SEWAGE DISPOSAL SYSTEM

SUBDIVISION Mt. Hebron ROAD 2605 Thornbrook Road LOT 35, Sec. 16

SEWAGE DISPOSAL TESTING

2605 THORNBROOK RD
"MT. HEBRON"

A 26782

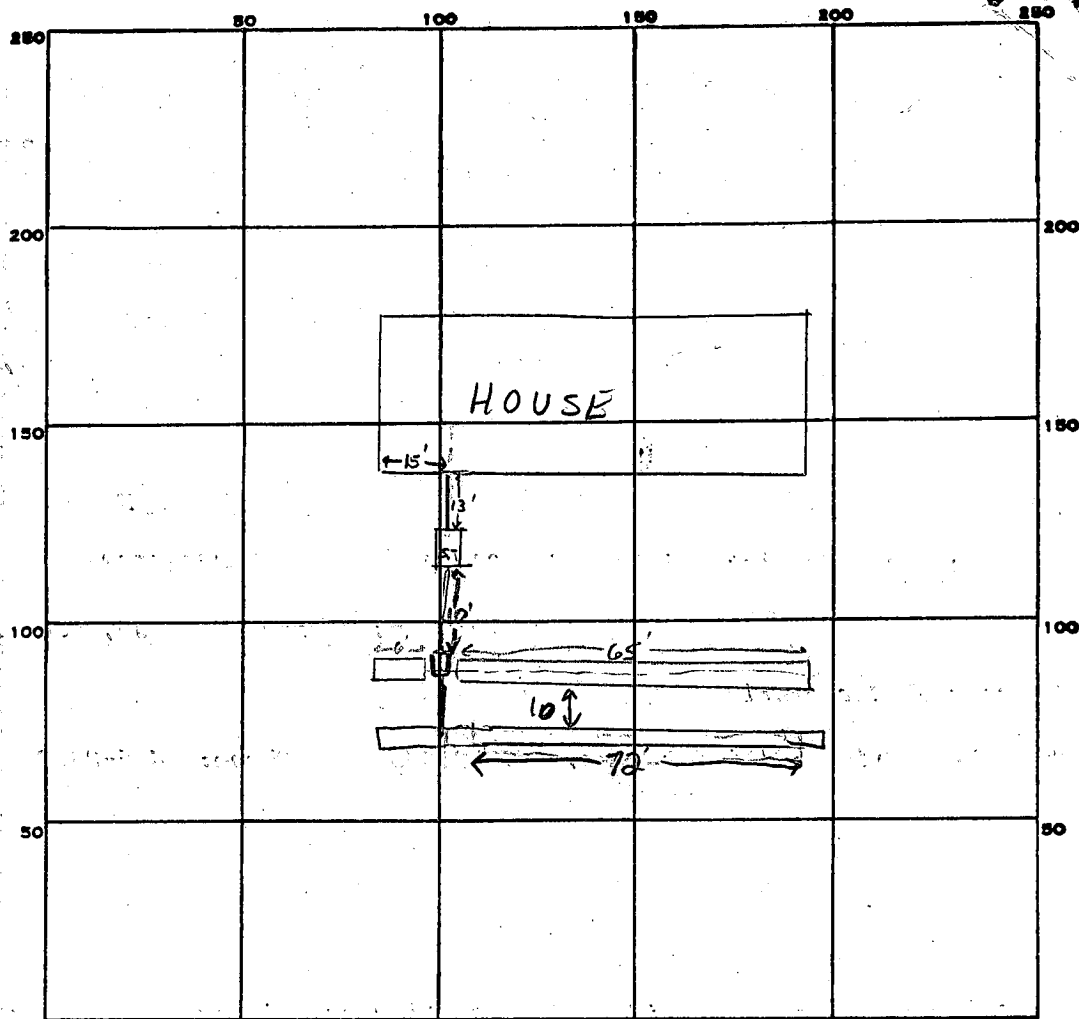
1st trench 71' long

2nd trench 72' long

REMARKS 5/10/84 OK to continue work. F.S.

5/11/84 2ND OK TO ADD GRAVEL TO SECOND TRENCH CW

5/11/84 SYSTEM COMPLETE. OK TO COVER ALL WORK. CW

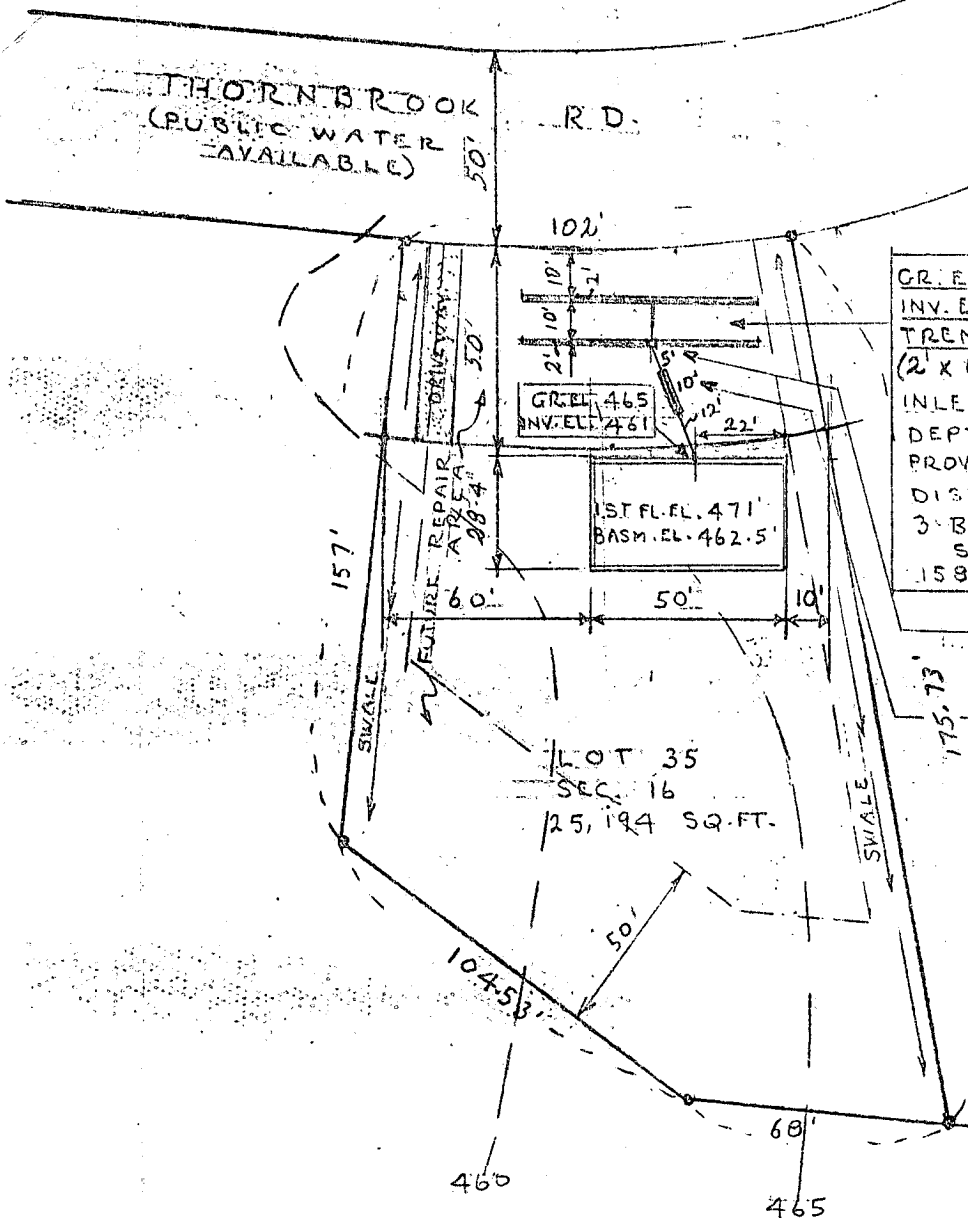
REASONS FOR REJECTION OR HOLDING Hold for wet season test F.S.

may also need more area to get required 10,000 ft. area

2/22/84
Revised Sketch
F.S.

GR. EL. 462.5'
INV. EL. 460'
TRENCHES: 2 FT. WIDTH
(2 X 60' = 120 LIN. FT.)
INLET 2'-6"; TOTAL MAX.
DEPTH 6'-6" BELOW ORIG. GRADE
PROVIDE 4" STONE BELOW
DISTRIBUTION PIPE
3 BEDROOMS - 1000 GAL
SEPTIC TANK
158 SQ. FT. X 3 = 474 SQ. FT.
